MEMORANDUM

From:	Tina Cuss Ecology Officer		
Service	WBC Ecology	App No:	252252
Address:	L'Ortolan Restaurant, Church Lane, Shinfield, Wokingham, RG2 9BY.		
Proposal:	Householder application for the proposed erection of a rooftop extension with terrace decking to the existing main building, alongside alterations to the fenestration; the erection of a rooftop infill extension to the annex building; the erection of a detached single-storey garage with dual-pitched tiled roof and facing brickwork and stone/render to match the main dwelling; landscaping and parking alterations; and the demolition of the existing single- storey rear kitchen/service extension.		
Type of Development:	Other Householder		
Site Visit Made:	No

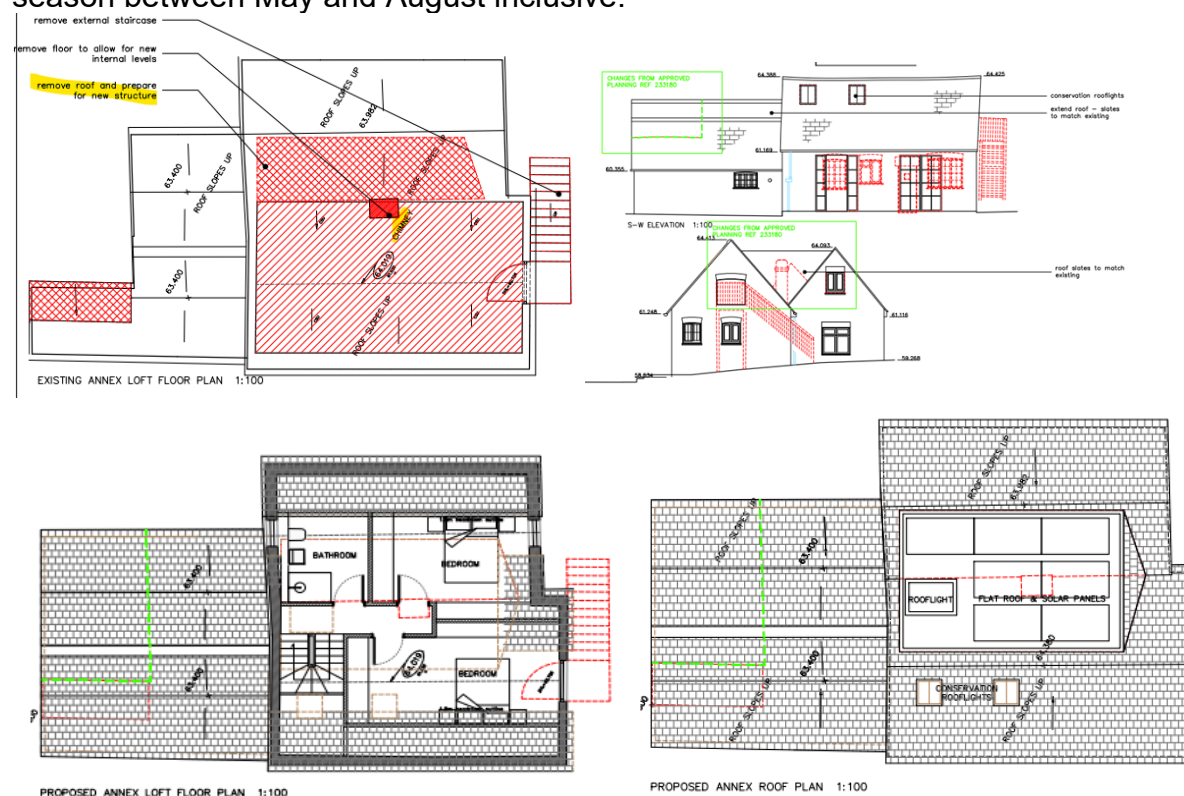
The semi-sheltered interface on the western elevation of B2, has observable gaps at junctions between buildings and under roof tiling which can act as thermal refuges and potential entry routes. The Ecologist concluded that *“given the structural links with B1, ecological risk associated with this elevation remains moderate, warranting further investigative assessment where development may directly impact roof connectivity or wall interfaces”*. However, according to the Trace Architects Existing Site Plans, the house B1 appears to be separated from the Annex B2 by a vegetable garden.

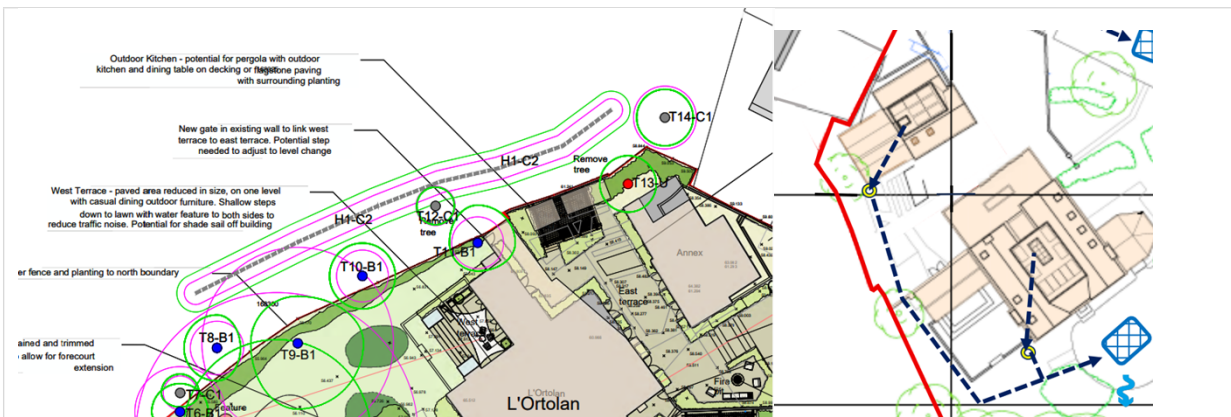
only be left to coverage under planning conditions in exceptional circumstances, with the result that the surveys are carried out after planning permission has been granted.” In this case, the extent to which bats may be affected by the proposals has not been established, and as there are no “exceptional circumstances”, the application would not be contrary to planning policy. Local Plan policies CP3 and CP7 are also not considered.
